Customer : CU-DAR001 Dart Helicopters Services Drawing Name : HELI UTILITY BASKET LH/RH 350/355
 Job Number : 37094
 Estimate Number : 10208
 P.O. Number :
 This Issue : 1/30/2008 S.O. No. :
 Prsht Rev. : NC
 First Issue : / / Type : LARGE FAB ASSY
 Previous Run : 37093
 Written By :
 Checked & Approved By : 08 01 30
 Comment : Est Rev:E as Per DSI9318 06-01-24 JLM
 Est Rev:F ECN1068 07-12-21 DD

DESIGN <i>CP</i>	DRAWN BY <i>CP</i>	DART AEROSPACE LTD HAWKESBURY, ONTARIO, CANADA	
CHECKED <i>[Signature]</i>	APPROVED <i>[Signature]</i>	DRAWING NO. DSI 9318	REV. A SHEET 1 OF 1
DATE 06.01.06		TITLE WASHER ADDITION	SCALE NTS
A	06.01.06	NEW ISSUE

DART SERVICE INSTRUCTION

TO AMEND INSTALLATION INSTRUCTIONS D350-607 REV. F

Figure 5- Basket Replacement Parts
(D350-607-043 Heli-Utility-Basket™)

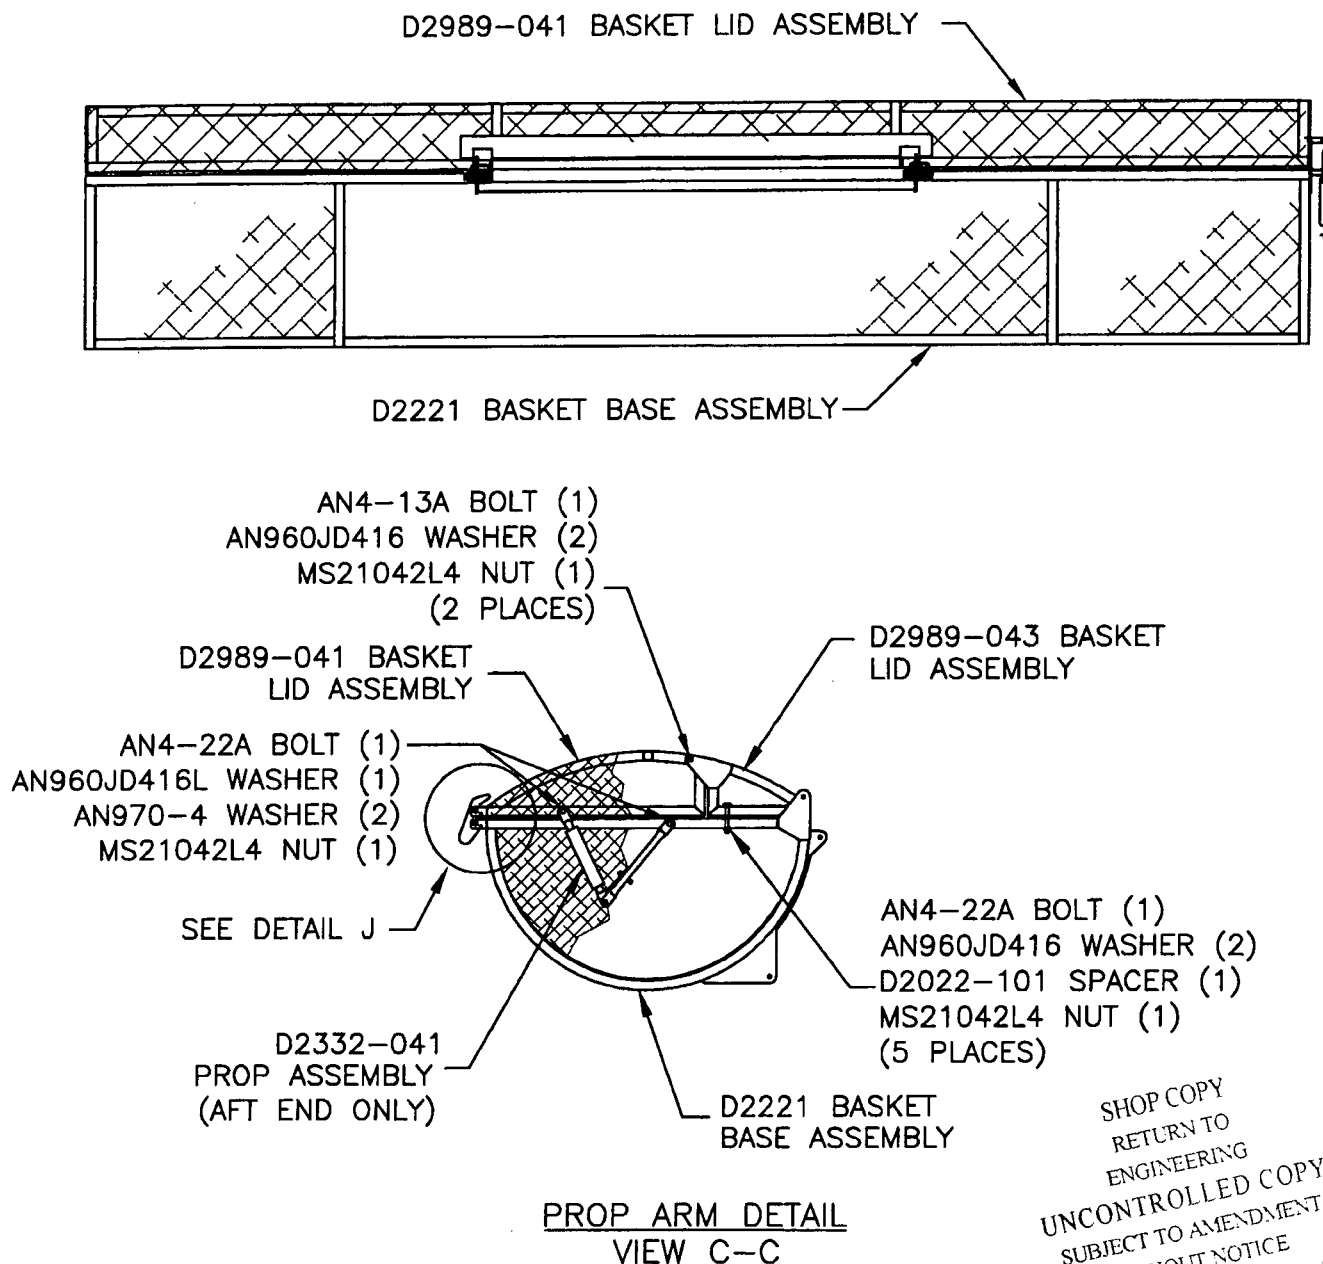
The corrected bolt stackup from Figure 5 of installation instructions D350-607 Rev. F is given below:

AN4-13A BOLT (1)
AN960JD416 WASHER (1)
HINGE PLATE (REF)
NAS1515H4 WASHER (1)
BASKET FRAME (REF)
AN960JD416 WASHER (1)
MS21042L4 NUT (1)
(2 PLACES)

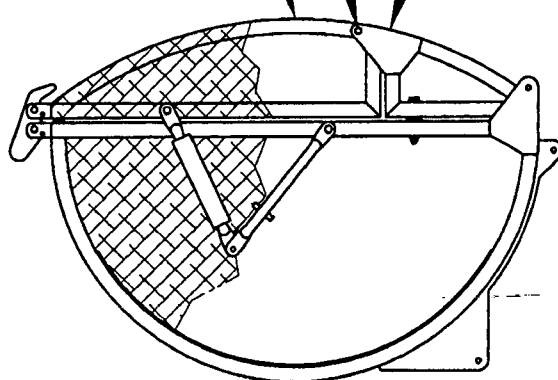
To reduce the possibility of damaging the finish, a **NAS1515H4** washer (2 places) has been added between the hinge plate and basket frame on the **D350-607-043/-047 Heli-Utility-Basket**.
